Subject: MHI's Response to US-APWR DCD RAI No. 303-2329 Revision 2

US-APWR Design Certification

RAI NO.: NO. 303-2329 REVISION 2

SRP SECTION: 15.02.01 – 15.02.05 – LOSS OF EXTERNAL LOAD; TURBINE TRIP; LOSS OF CONDENSER VACUUM; CLOSURE OF MAIN STEAM ISOLATION VALVE (BWR); AND STEAM PRESSURE REGULATOR FAILURE (CLOSED)

**Figure 15.2-1.1 DNBR versus Time with and without LOOP
Loss of Normal Feedwater Flow**

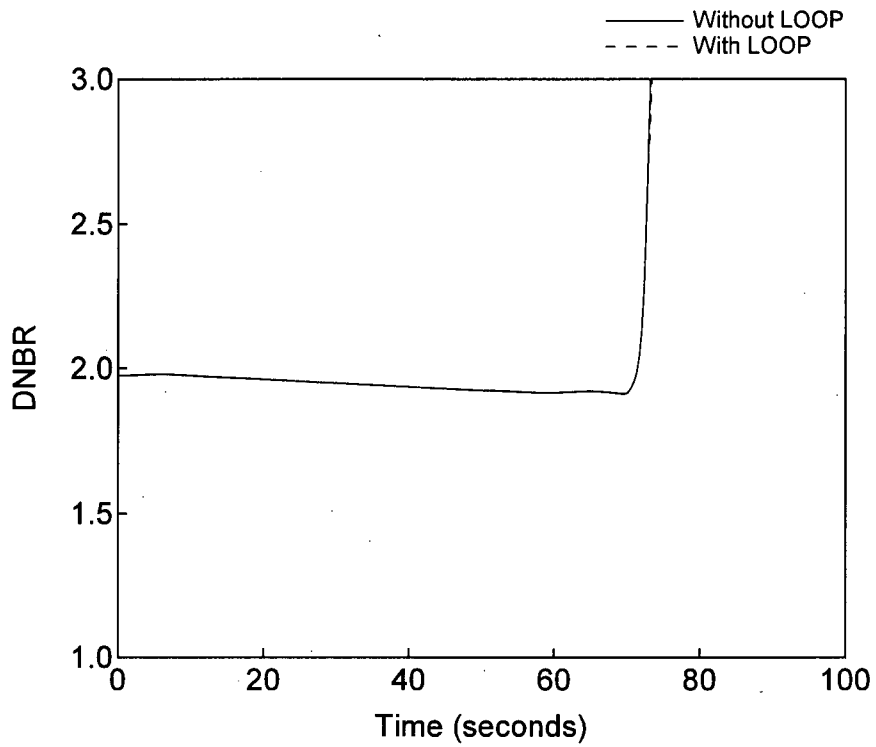
SRP Sections 15.2.1-5 and 15.2.7 state, "For new applications, LOOP should not be considered a single failure; [all AOOs] should be analyzed with and without LOOP in combination with a single active failure." In compliance with this requirement, provide the results of calculations that include the occurrence of a LOOP unless otherwise exempted by the NRC staff. If exempted by the NRC, provide documentation of the exemption.

A sensitivity analysis concerning the US-APWR LOOP assumptions and their supporting bases is described in detail in the response that is being submitted for Question 15.0.0-3 of RAI 297-2287. That response includes a comparison of the DCD Subsection 15.2.1 (loss of external load) analysis with and without LOOP.

Figure 15.2-1.1 below provides the transient DNBR curve for the loss of normal feedwater event in DCD Subsection 15.2.7 considering a LOOP, in which the reactor coolant pump coastdown is delayed 3 seconds after turbine trip (turbine trip is assumed to occur at the same time as reactor trip). For comparison, the curve without LOOP is provided on the same figure. For the DNBR figures shown in this response, the results are generated using the MARVEL-M/VIPRE-01M methodology rather than the MARVEL-M lookup table methodology utilized in the DCD. Both of these methodologies are described in detail in the Non-LOCA Methodology Topical Report (MUAP-07010). Since it was necessary to use the MARVEL-M/VIPRE-01M methodology for the LOOP case due to the flow coastdown, the same methodology was used for the without LOOP (i.e., DCD) case for consistency.

Figure 15.2-2.1 RCP Outlet Pressure versus Time
Comparison of Turbine Trip with LOOP to
DCD 15.2.1 Case (Loss of External Load)

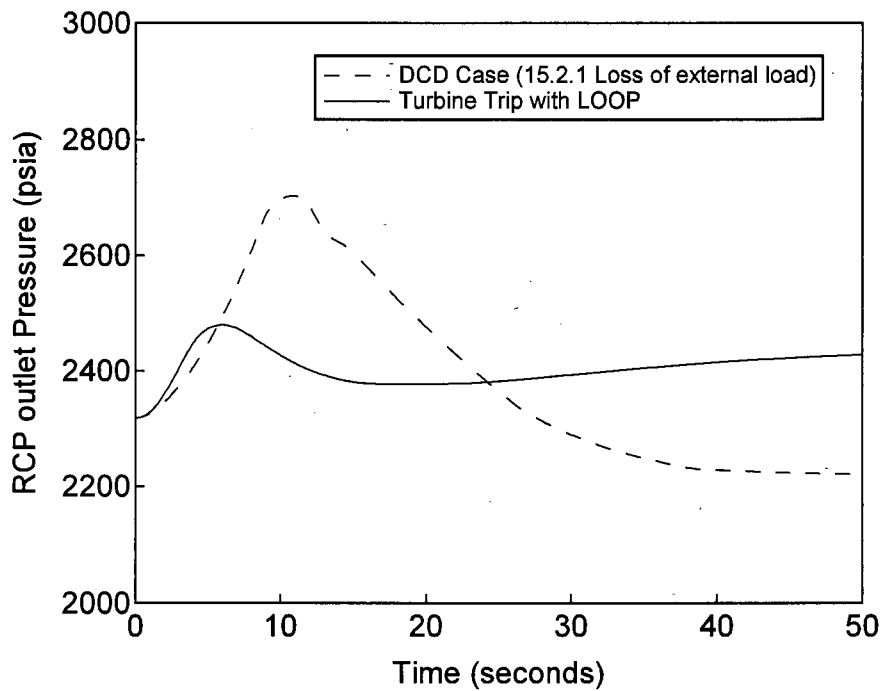
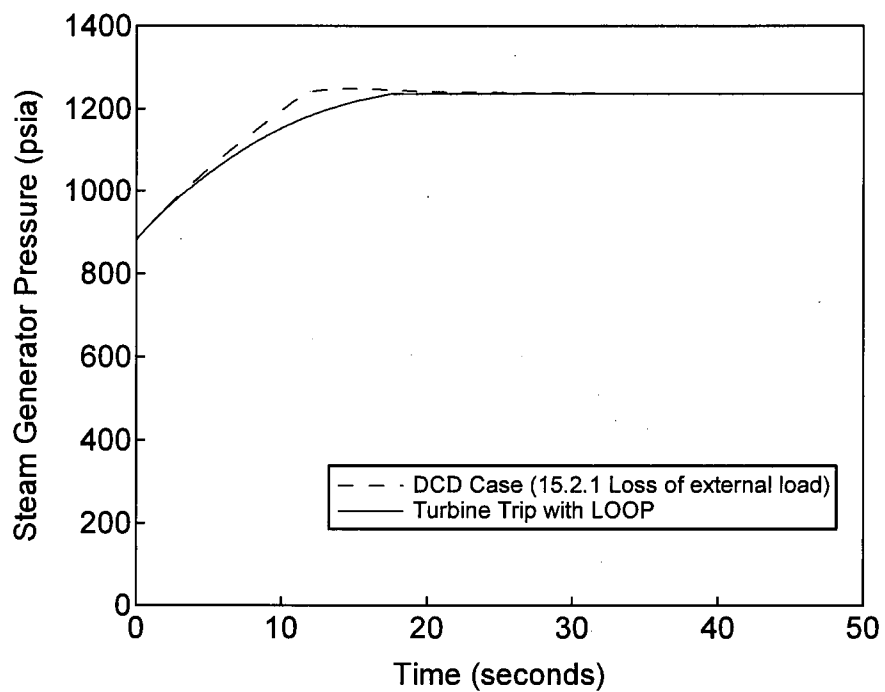
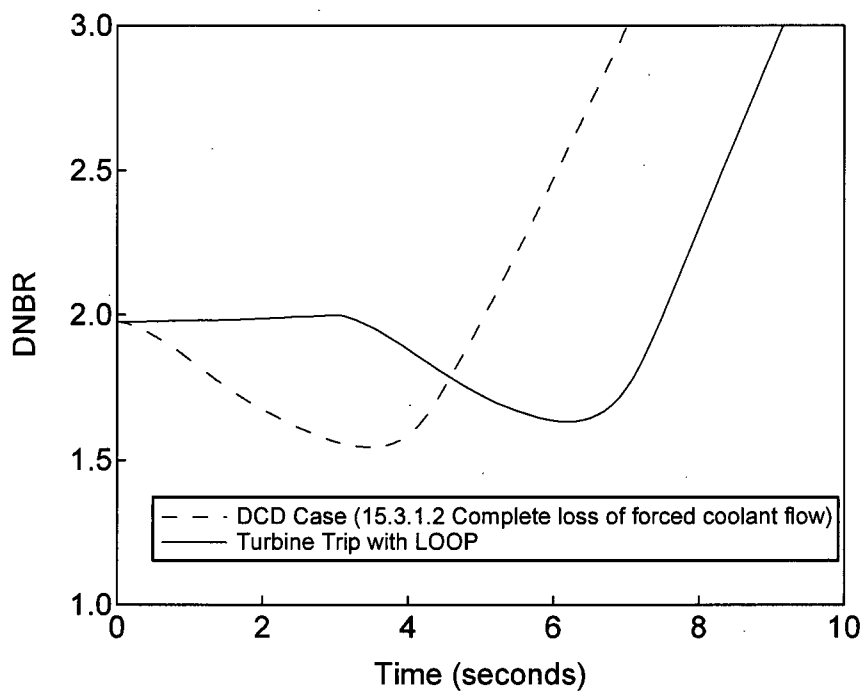
In DCD Section 15.2.1, Loss of External Load, the direct reactor trip on turbine trip is not credited in the analysis. Instead, the reactor trip is initiated at 8.5 seconds after turbine trip for the DNBR analysis and 8.7 seconds after turbine trip for the RCS analysis, following the receipt of the high pressurizer pressure signal. Minimum DNBR is calculated to occur one second later in both analyses. It appears from the results presented that the RCPs continue to operate for the duration of the transient. Explain the logic as to why the turbine trip does not result in a trip and coast down of the RCPs. What would be the results if the RCPs coasted down following the turbine trip as proposed in DCD Section 15.0.0.7?

For the case where the loss of main steam flow is the result of a turbine trip that occurs at time zero, the event could be mitigated by crediting the direct reactor trip on turbine trip. A LOOP may occur following the turbine trip, causing all RCPs to coast down 3 seconds later. If the direct

reactor trip on turbine trip is conservatively not assumed, then the DNBR response for this event is very similar to and is bounded by the complete loss of forced reactor flow event in DCD Subsection 15.3.1.2. This scenario, with LOOP, was analyzed for the RCS pressure, main steam pressure, and DNBR responses. Figures 15.2-2.1 and 15.2-2.2 below show the RCP outlet and steam generator pressure responses, respectively, and Table 15.2-1.1 lists the key events and times at which they occur, relative to the initiation of the transient. For the RCS and main steam pressure response, the 3 second delay between turbine trip and LOOP/RCP coastdown is conservatively not credited (see the response to Question 15.0.0-3 of RAI 297-2287 for a full sensitivity analysis to all LOOP assumptions). The peak RCP outlet and steam generator pressures remain below 110% of their respective design pressures, and are bounded by the existing analysis in DCD Subsection 15.2.1, loss of external load, as shown in the figures. Figure 15.2-2.3 below shows the DNBR response and Table 15.2-1.2 lists the key events and times at which they occur, relative to the initiation of the transient. The minimum DNBR remains above the 95/95 DNBR design limit and is bounded by the existing analysis in DCD Subsection 15.3.1.2, complete loss of forced reactor flow, as shown in the figure.

In summary, the LOOP cases following turbine trip have been provided and confirm the explanation in DCD Subsection 15.0.0.7 that the LOOP portion of these events is not limiting with respect to peak RCS pressure or DNBR.

Figure 15.2-4.1 Assumption of Main Steam/Feedwater Flow in DCD

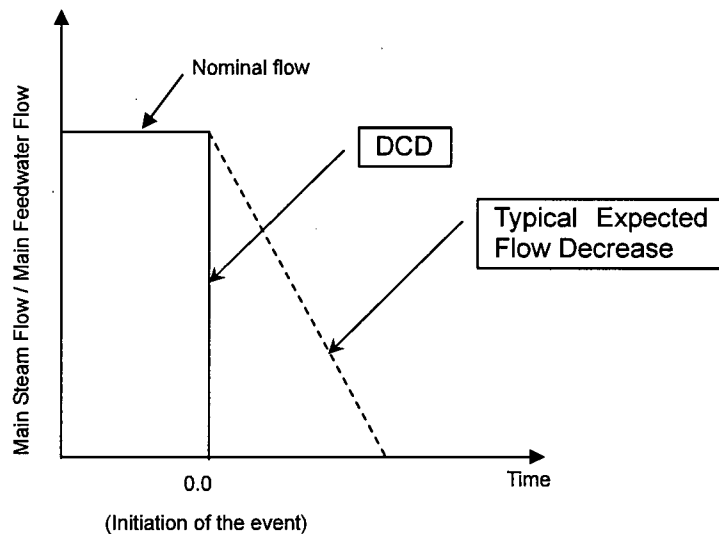
In DCD Section 15.2.2, Turbine Trip, the argument is made that this event is similar to the loss of external load transient and is bounded by the results for DCD Section 15.2.1, except that the steam flow following a turbine trip transient would be isolated by closure of the main turbine stop valves rather than the main turbine control valves (as in the case for DCD Section 15.2.1). Provide quantitative justification for why DCD Section 15.2.2-15.2.4 events are bounded by the analysis presented in DCD Section 15.2.1.

The single initiator for all of the events in DCD Subsections 15.2.1 to 15.2.5 is the sudden reduction of main steam flow (including the sudden reduction of main feedwater flow). For all SRP Section 15.2 AOOs, this reduction in steam flow combined with the time delay until reactor trip signals are reached, causes a RCS heatup that can challenge the acceptance criteria. Therefore, these events are very similar, regardless of their specific cause or timing of the reduction in steam flow. For this reason, conservative assumptions were made in DCD Subsection 15.2.1 to assure that the analysis would bound all these events. SRP 15.2.1 to 15.2.5 discusses the differences between these events due to valve closure time and the status of feedwater pumps. However, for the DCD, the bounding condition assumed in the analysis is that both main steam flow and main feedwater flow instantaneously decrease from their initial conditions to zero at time zero. This is the most severe case possible, since all steam flow ceases at time zero, rather than allowing for some additional steam flow early in the event. As indicated in Figure 15.2-4.1, the triangular area under the dashed line represents additional steam flow that can occur, thus mitigating the RCS heatup. By assuming instantaneous valve closure, this additional steam flow is not credited. Therefore, the analysis in DCD Subsection 15.2.1 bounds all of the events in DCD Subsections 15.2.1 to 15.2.5.
